Marine Advisory: 34/2025

SUBJECT: Amendments to the International Code for the Safe Carriage of Grain in Bulk

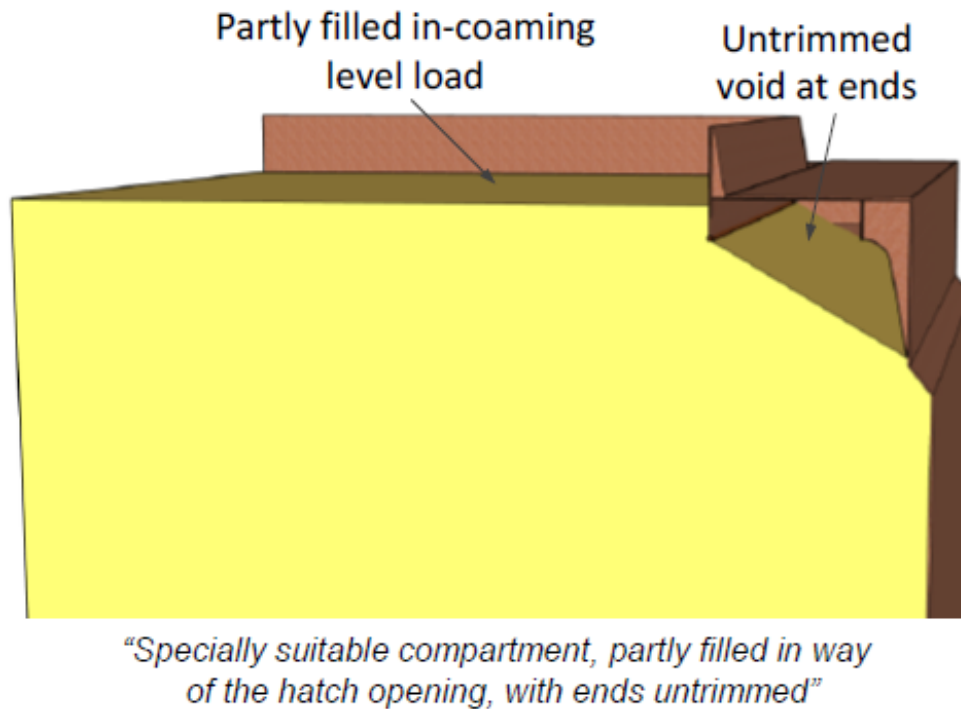
The International Grain Code as originally adopted contained the following three (3) loading conditions:

- "filled compartment, trimmed" - any cargo space in which, after loading and trimming, the bulk grain is at its highest possible level.
- "filled compartment, untrimmed" - a cargo space which is filled to the maximum extent possible in way of the hatch opening but which has not been trimmed outside the periphery of the hatch opening, either as allowed for all ships or for "specially suitable compartment" (typically bulk carriers with sloping top-side tanks), under the applicable provisions of the Code.
- "partly filled compartment" - any cargo space wherein the bulk grain is not loaded in the manner described above.

In the practice of loading ships with grain, a loading condition that has been frequently observed is where a "specially suitable compartment" is filled up to or above the bottom edge of the hatch end beams, but not to the highest possible level in way of the hatch opening. It was brought to the attention of IMO that this situation is not specifically addressed in the Code, leading to uncertainty in application of the Code and possible lack of information necessary to evaluate the safety of a ship under such a loading condition.

- “specially suitable compartment, partly filled in way of the hatch opening, with ends untrimmed” - a specially suitable compartment which is not filled to the maximum extent possible in way of the hatch opening but is filled to a level equal with or above the bottom edge of the hatch end beams and has not been trimmed outside the periphery of the hatch opening.

Amendments were also made to allow loading grain in the newly defined condition along with amendments to the calculation of assumed heeling moments to account for grain loaded this way.
